Chevrolet Dealer Service Technical Bulletin

68-T-62

Subject: LOW FUEL ECONOMY -
1968 CHEVROLET VEHICLES

(FIGURE 1)

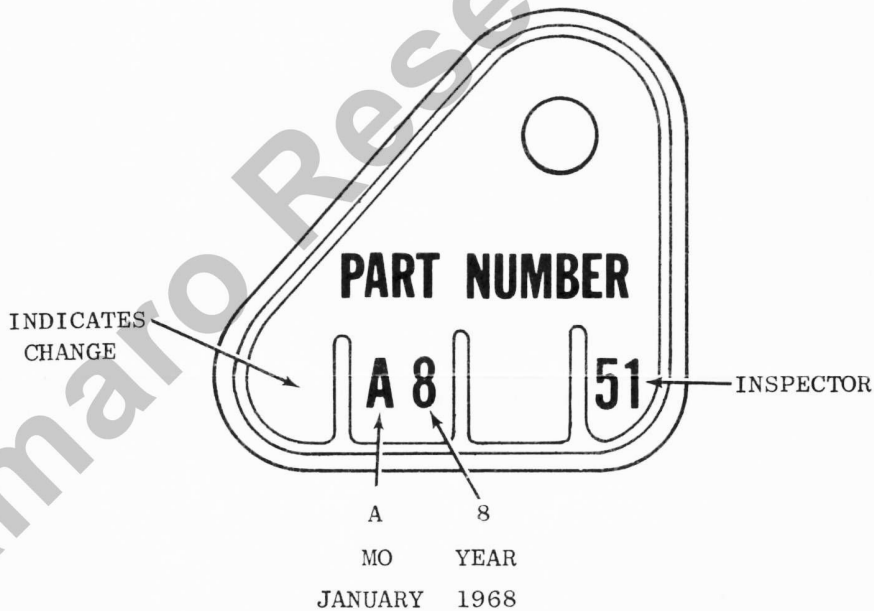
1. On passenger cars with 307 or 327 cu. in. engine, with 2-barrel carburetor and automatic transmission, there were some carburetors built prior to January 1968 that were on the "rich" side of the desired flow band. These units could be improved by changing the main metering jets from .052 to .050 (Service Part No. 7002650). However, caution should be exercised in the installation of these leaner jets as "leaning" a "mean" limit carburetor could result in surge and/or detonation and no gain in economy.

To identify the build date of a carburetor, check the triangular tag which is attached to the front of the carburetor (See Fig. 1).
